November 21, 2014

SUBJECT: INTEGRATION OF MITIGATING STRATEGIES FOR BEYOND-
DESIGN-BASIS EXTERNAL EVENTS AND THE REEVALUATION
OF FLOODING HAZARDS

Figure 1: Conceptual illustration of integrated assessment implementation process (Ref. [2])

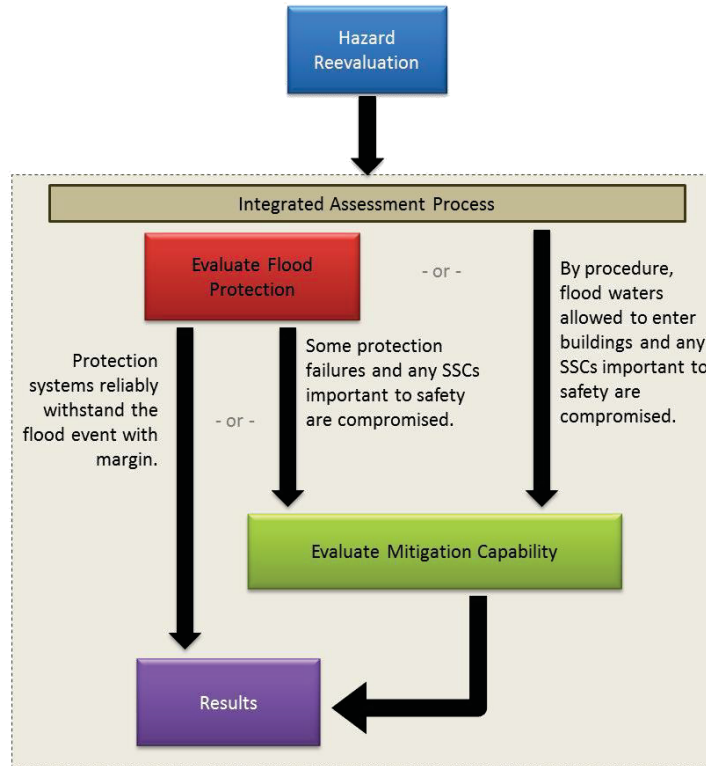
(e.g., sandbags); pumps and valves; and associated manual actions. The IA ISG also includes guidance to support three different types of evaluations of flood-specific mitigation capability.¹⁰ Thus, the integrated assessment ISG includes guidance to support conventional engineering evaluations of flood protection (e.g., appropriate codes/standards for flood protection) in response to the reevaluated hazard, as well as equipment reliability assessment, manual action evaluations, and use of PRA concepts and tools (e.g., event and fault trees).

The referenced figure (Figure 1) and related descriptions from JLD-ISG-12-05 do not reflect the approach described in the regulatory basis for the MBDBE rulemaking or the COMSECY. The recommended approach includes imposing a regulatory requirement through the MBDBE rulemaking to ensure mitigating strategies for beyond-design-basis external events address the reevaluated flooding hazards identified from Recommendation 2.1. The inclusion of a requirement within the MBDBE rule for mitigation of the reevaluated flooding hazard necessarily leads to changes in the Phase 2 decisions on regulatory actions for improved flood protection or mitigation. Changes to the decision-making process (based on the “results” box in the figure) in turn leads to changes in the information collection and assessments needed to support such decisions. In the context of the figure, the approach in JLD-ISG-12-05 currently calls for the flooding reevaluations to support an integrated assessment (total plant) which considers possible actions to improve flood protection and/or mitigation. The results from this integrated assessment are input to Phase 2 decision-making, including the need to address requirements for evaluating plant-specific backfits. However, the NRC staff is including a recommendation in the COMSECY for the Commission to affirm that regulatory requirements for mitigating strategies need to address the flooding scenarios from the reevaluations. The result of this recommended approach is more certain and timely implementation of safety enhancements to address reevaluated flooding hazards.

Figure 2: Illustration of the difference between the reevaluated flood level and the consequential flood level

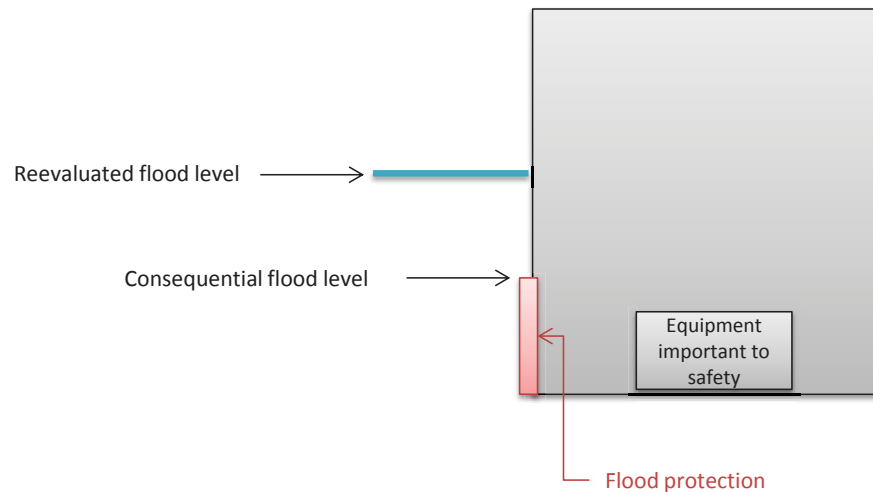
The COMSECY focuses primarily on this single maximum credible flood but does not address the importance of smaller events that still may be consequential to a site. Figure 2 shows an illustration of the difference between the reevaluated flooding hazard and the hazard that may be consequential to a site as a result of, for example, overtopping of flood barriers. This information about a “cliff-edge” significantly below the maximum credible flood height (as defined by the reevaluated flooding hazard) provides an important insight into whether additional regulatory actions are appropriate. However, under the proposed path described in the COMSECY, this type of information will not be collected. Moreover, it will not be clear whether there is a premature reliance on mitigating strategies for smaller, more frequent flooding events. Finally, under the proposed path described in the COMSECY, it will not be clear if relatively simple and potentially inexpensive actions (e.g., use of temporary berms, sandbags, or flood gates) could protect against the reevaluated hazard or smaller events and may represent a cost-justified safety enhancement.

Figure 2
(re-created from NCP-2014-10)

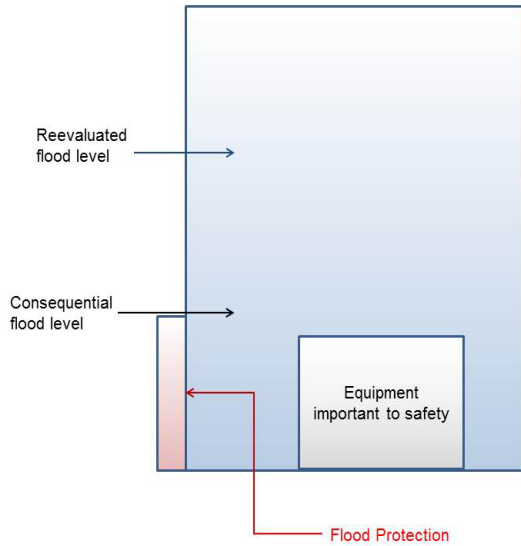
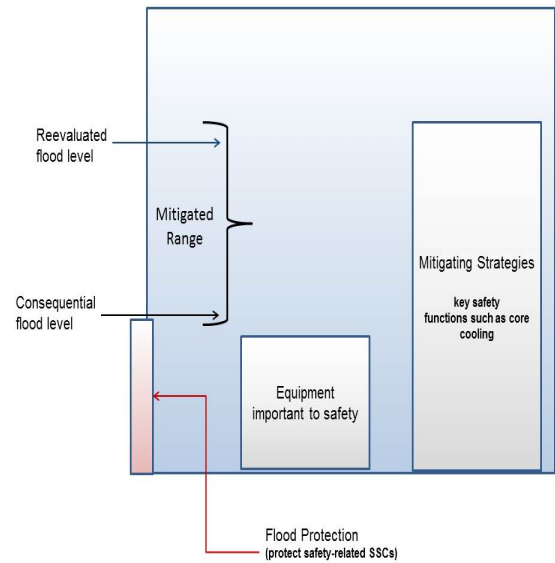
The authors of the non-concurrence provide a figure (Figure 2) to help describe the concept of cliff-edge effects and the possible implications of a range of flooding scenarios from various mechanisms (e.g., precipitation, dam failures). However, to reflect the approach described in the COMSECY, the figure would need to be revised to reflect that the requirements for mitigating strategies to include capabilities to address the reevaluated flooding hazards (Figure 3).

The NRC staff acknowledges that a variety of flooding scenarios exist and result in a range of possible conditions. These include floods protected against by existing flood protection measures to those up to the maximum reevaluated flood level. As previously discussed, the approach described in JLD-ISG-12-05 involves assessing the range of events but would require a separate regulatory action be taken to provide actual safety improvements. The approach recommended in the COMSECY involves including a regulatory requirement in the MBDBE rulemaking ensuring at a minimum that mitigating strategies address the various scenarios from reevaluating flooding hazards. The assessments of mitigating strategies equipment and actions would ensure protection against various flooding mechanisms and conditions identified from the flooding reevaluations. Mitigating strategies would therefore need to address scenarios that could range from slightly above the design-basis flood to significantly above the design-basis flood and depending on the site, scenarios involving different warning times, debris loads, and event durations. The range of conditions from the existing flood protection up to the reevaluated flood level is addressed by the mitigating strategies (mitigated range in Figure 3). Plant-specific questions, if pursued, would be whether the range of events covered by mitigating strategies – using the acceptance criteria of providing key safety functions (e.g., preventing core damage) is reasonable or if a case could be made for increasing the flooding protection for all safety-related SSCs or some subset of equipment that is important to safety (e.g., normal electrical supplies). The evaluation of additional measures in accordance with established rules and procedures would consider factors such as:
